Town of Hilton Head Island

Design Review Board Meeting

Tuesday, September 24, 2024, 2:30 PM

Town of Hilton Head Island DESIGN REVIEW BOARD MEETING Tuesday, September 10, 2024, 2:30 PM Minutes

MURAL APPROXIMATE SIZE 37' x 10'

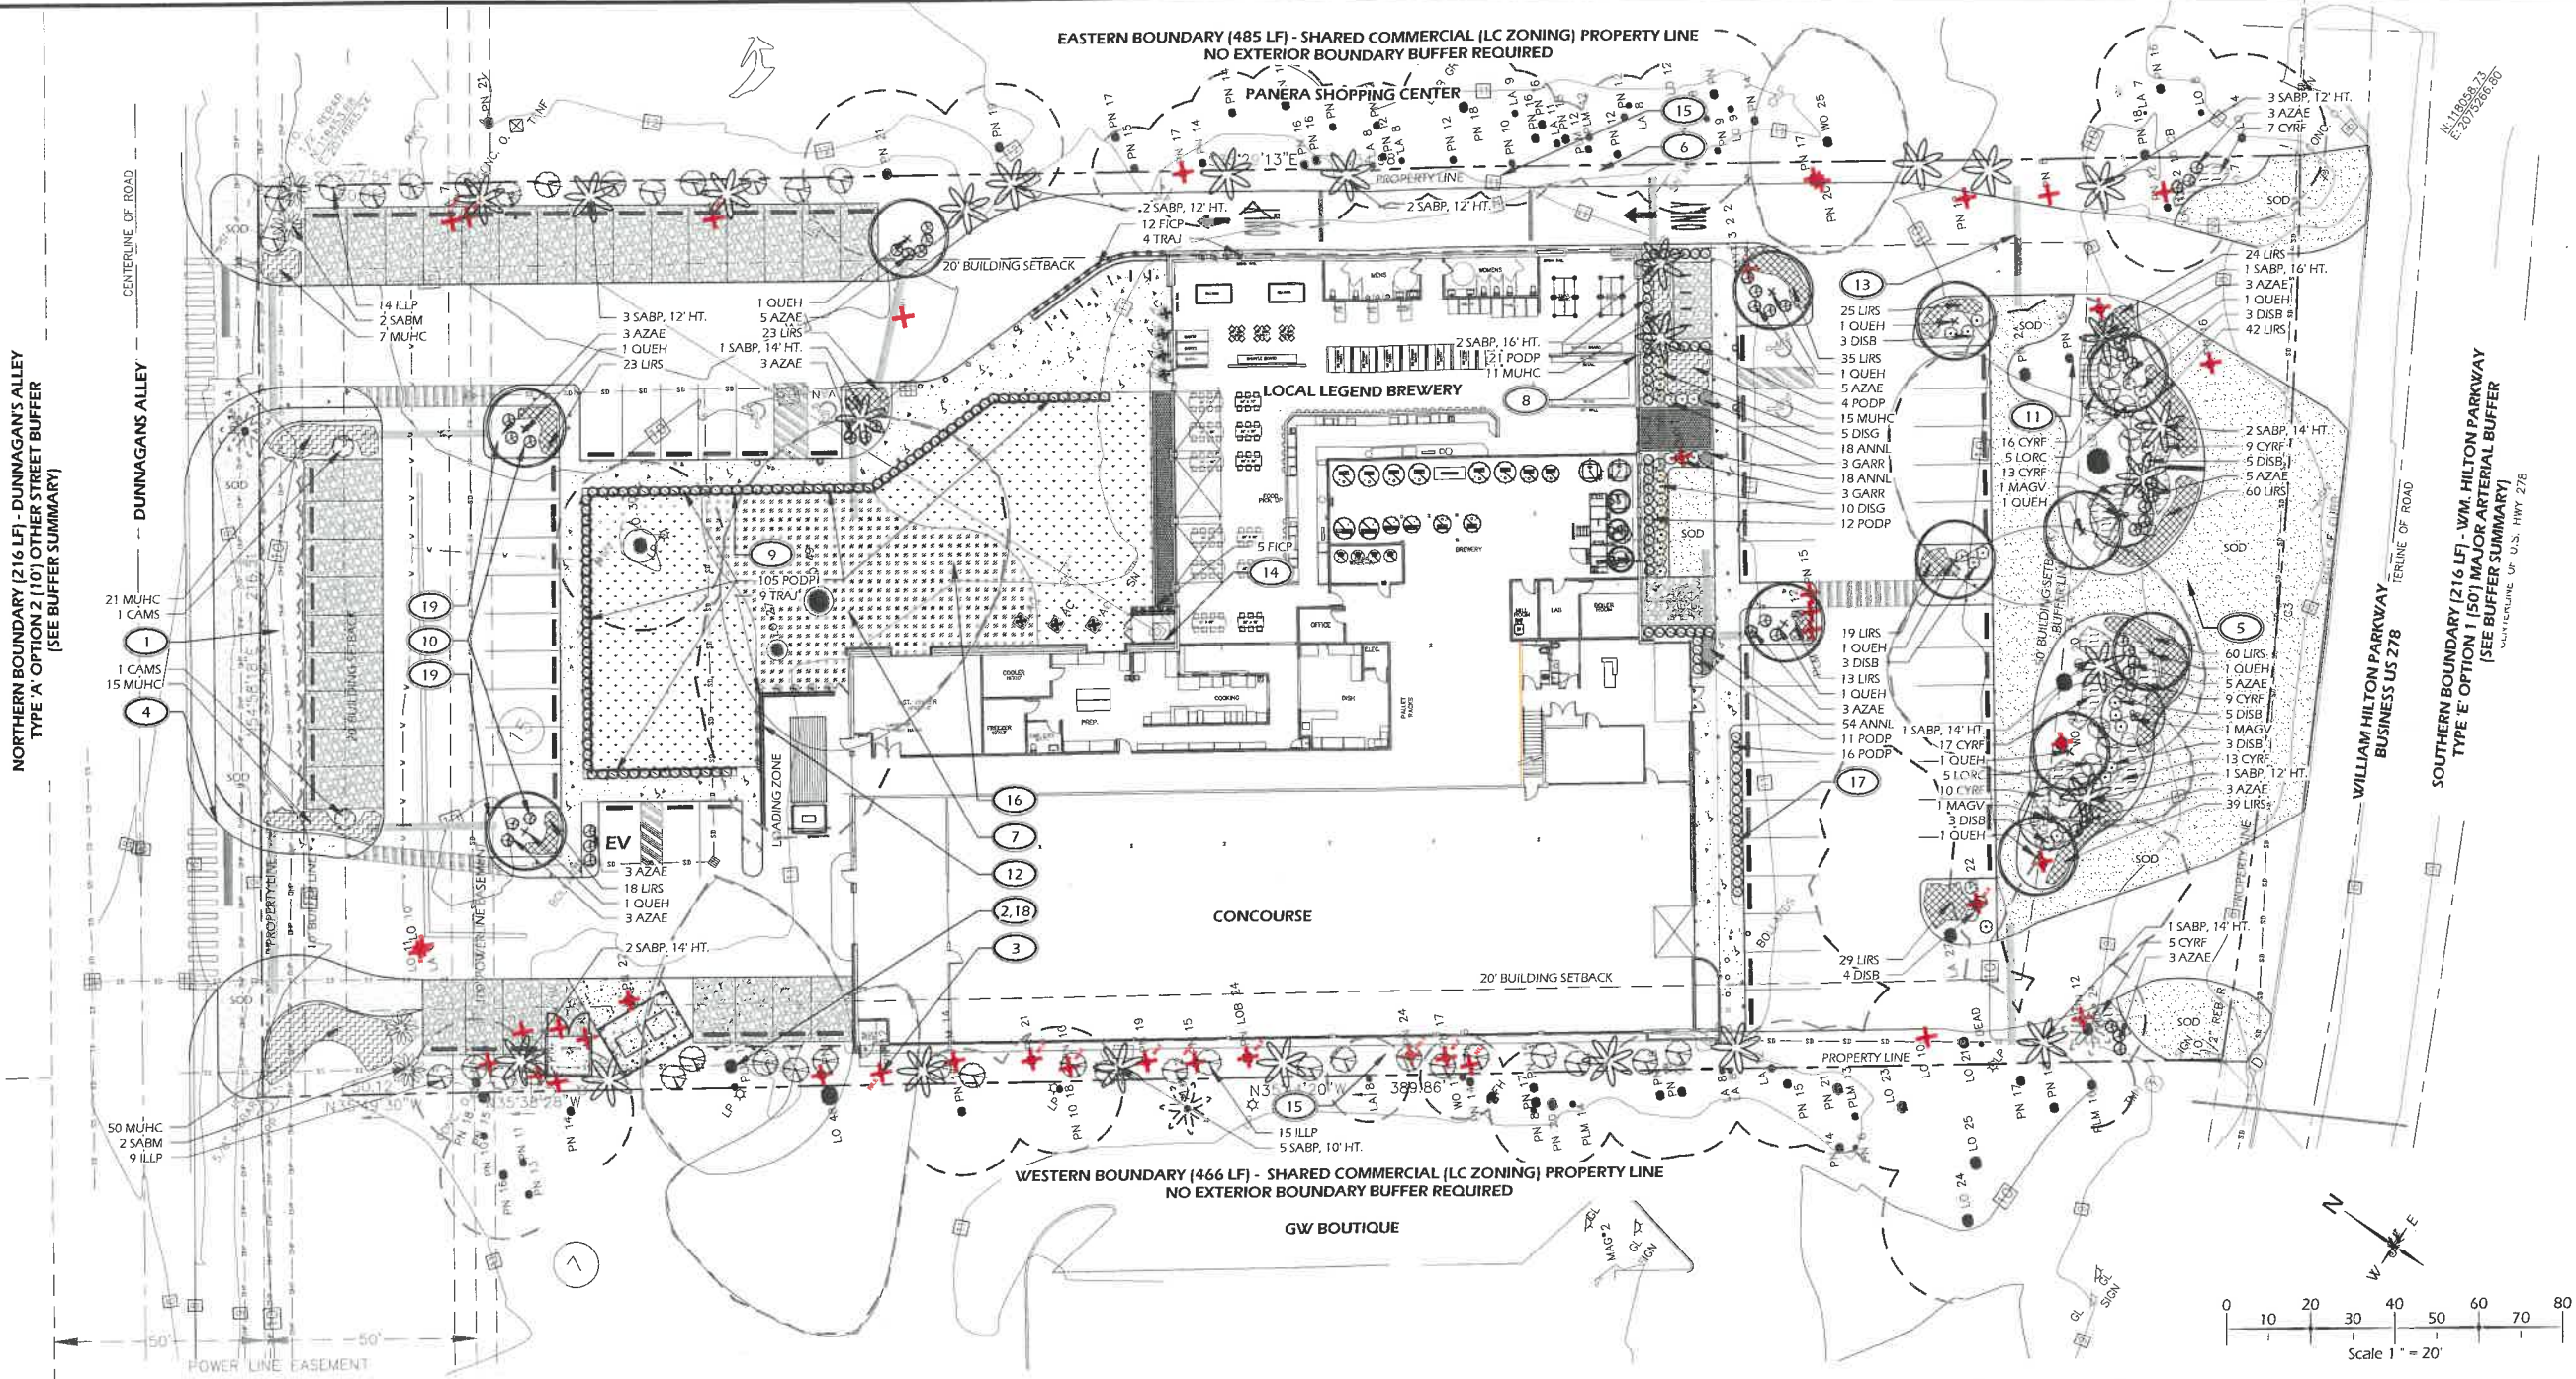
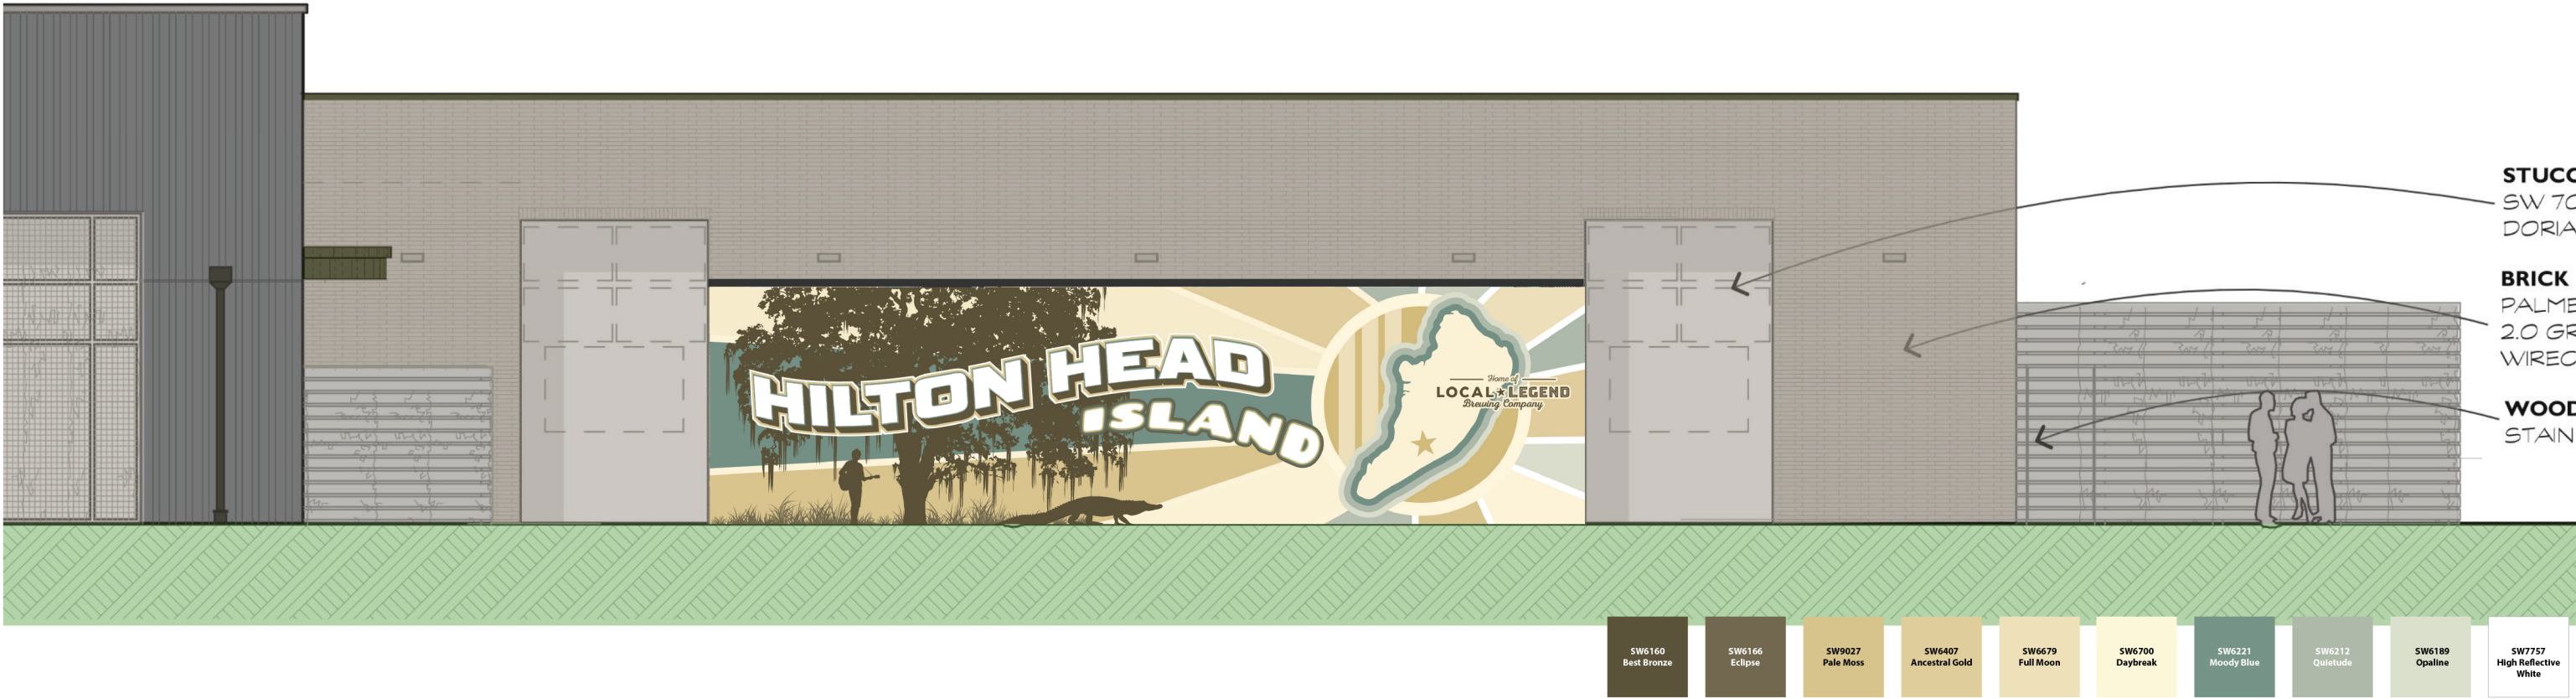
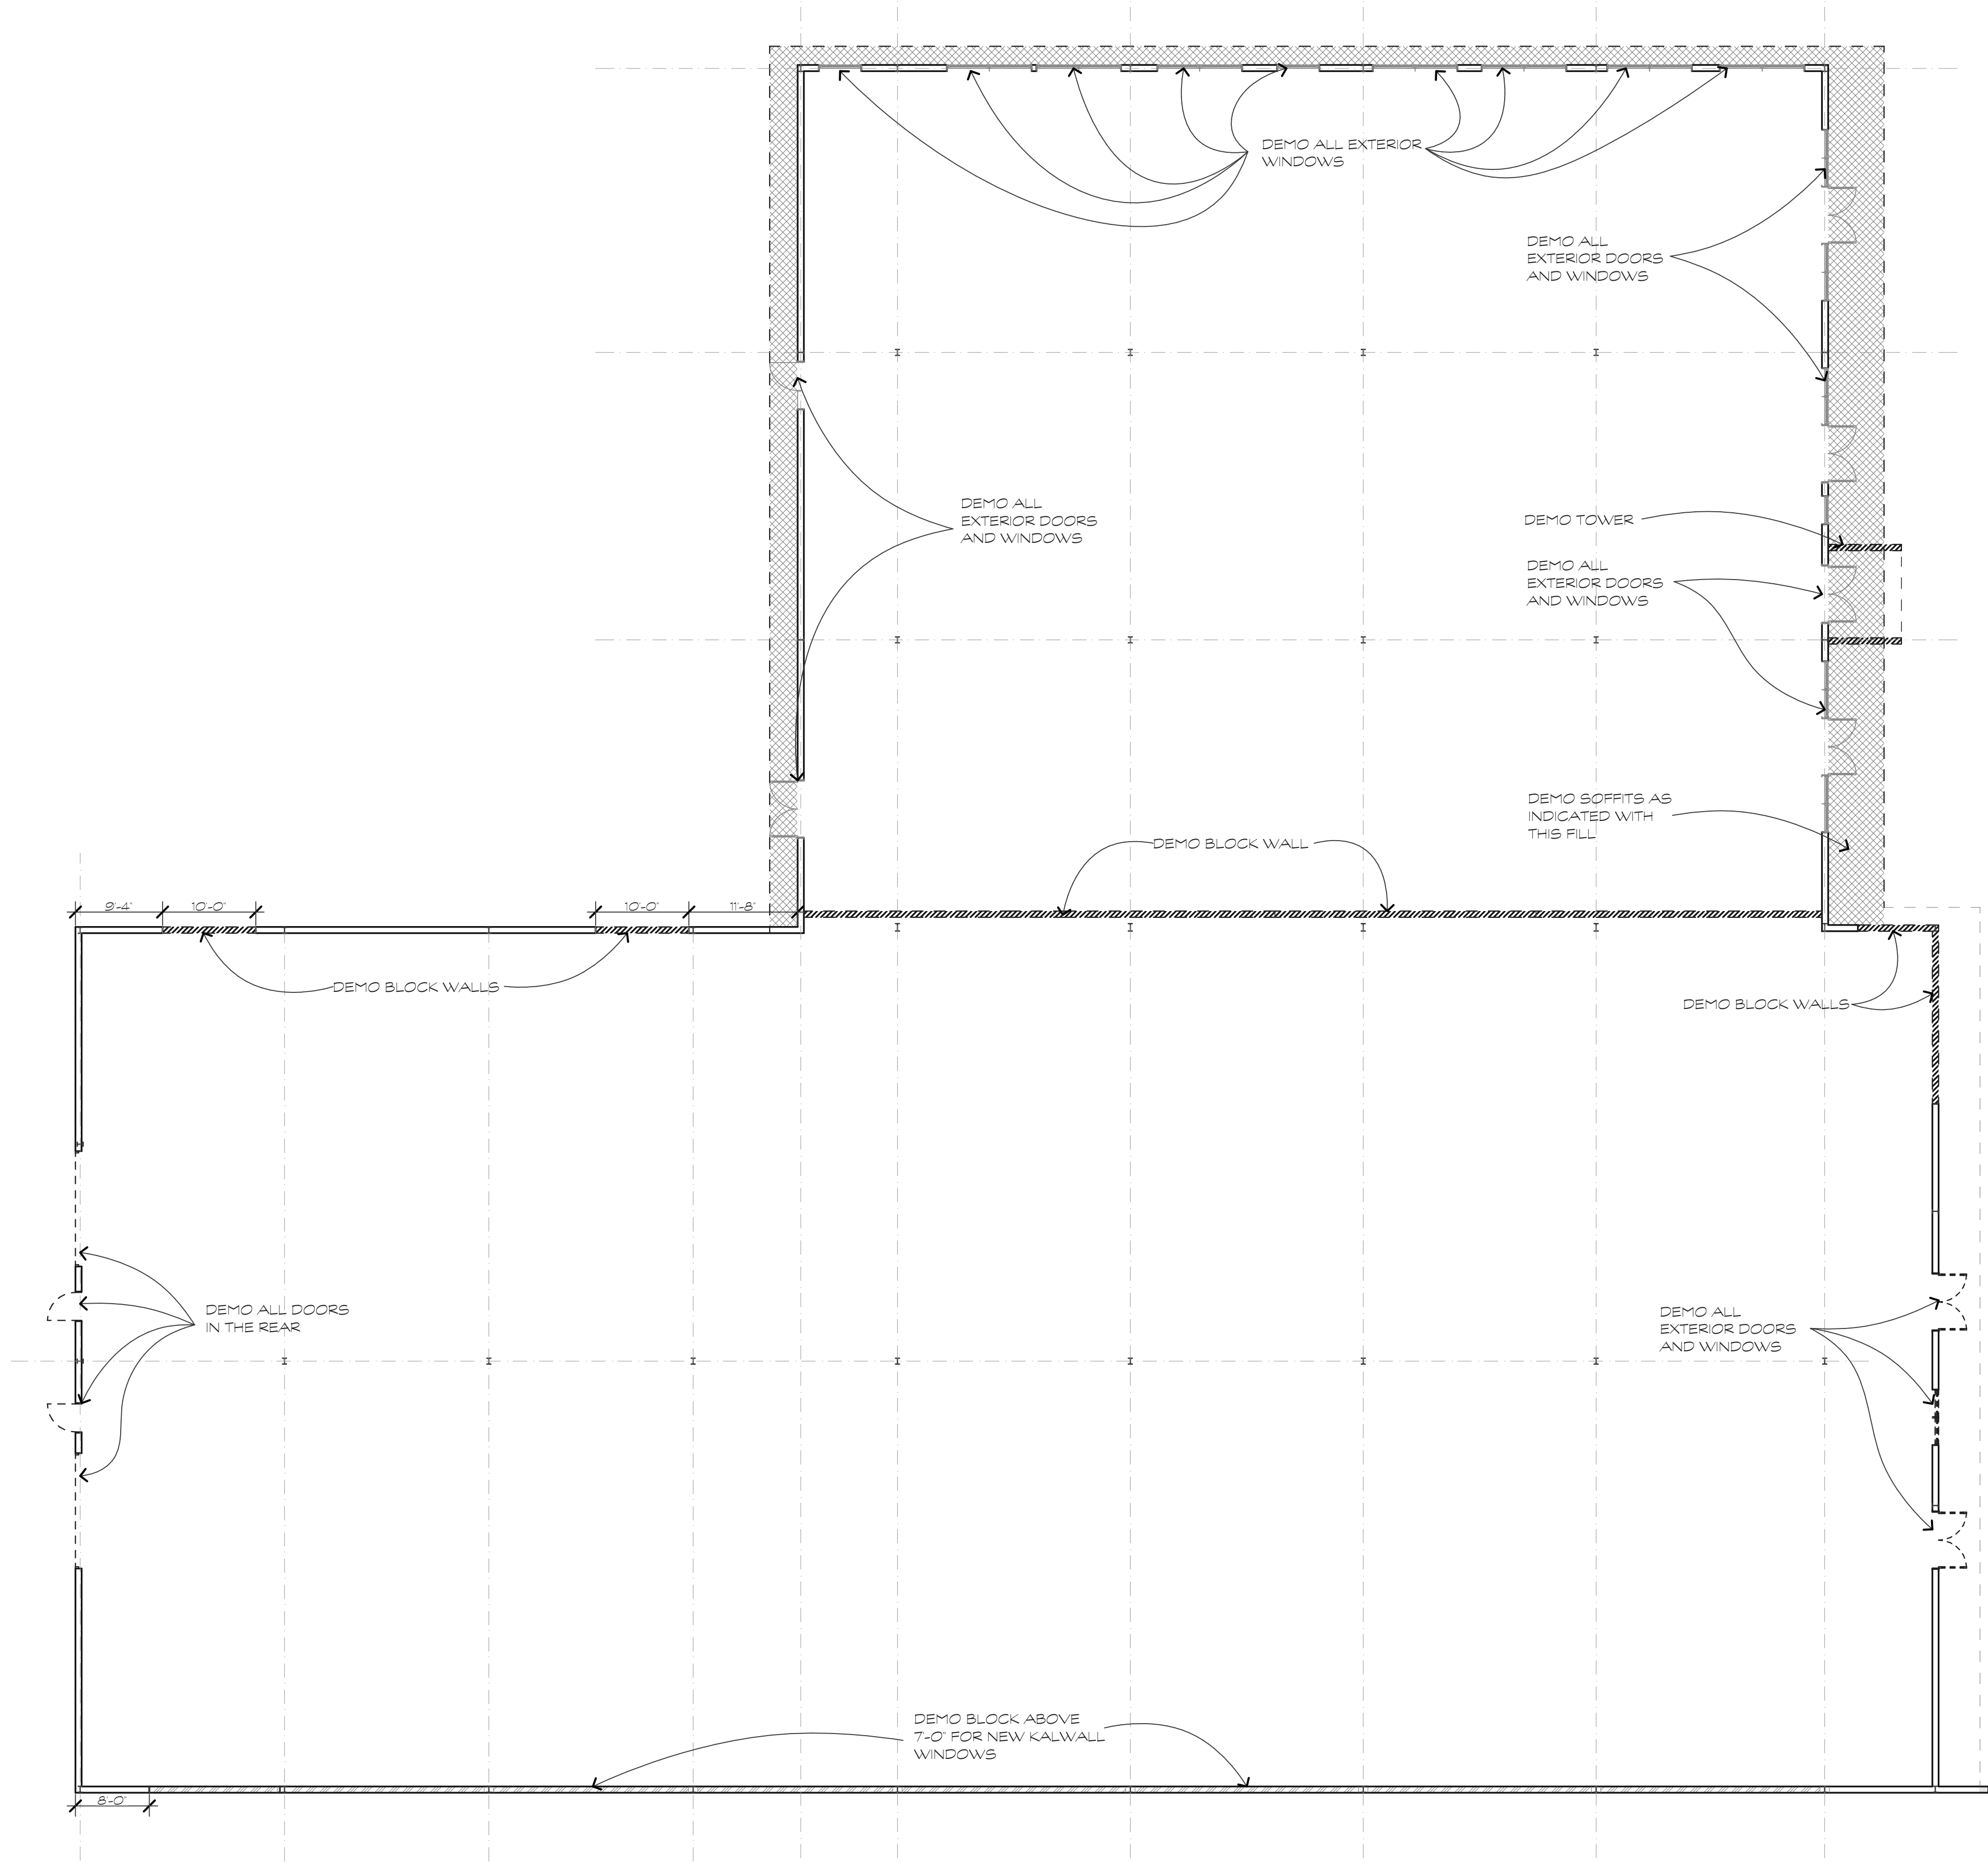
Mr. Theodore expressed concern that the mural might be considered a sign rather than artwork. He preferred muted colors and suggested distressing the design to create a weathered appearance. Ms. Fitzpatrick agreed with Mr. Theodore's color preferences and

shared the concern about the mural being classified as a sign. She requested a scaled design that includes the food court oak trees to better visualize the mural in its setting and asked for clarification on the amount of square footage being used for other signage on the property.
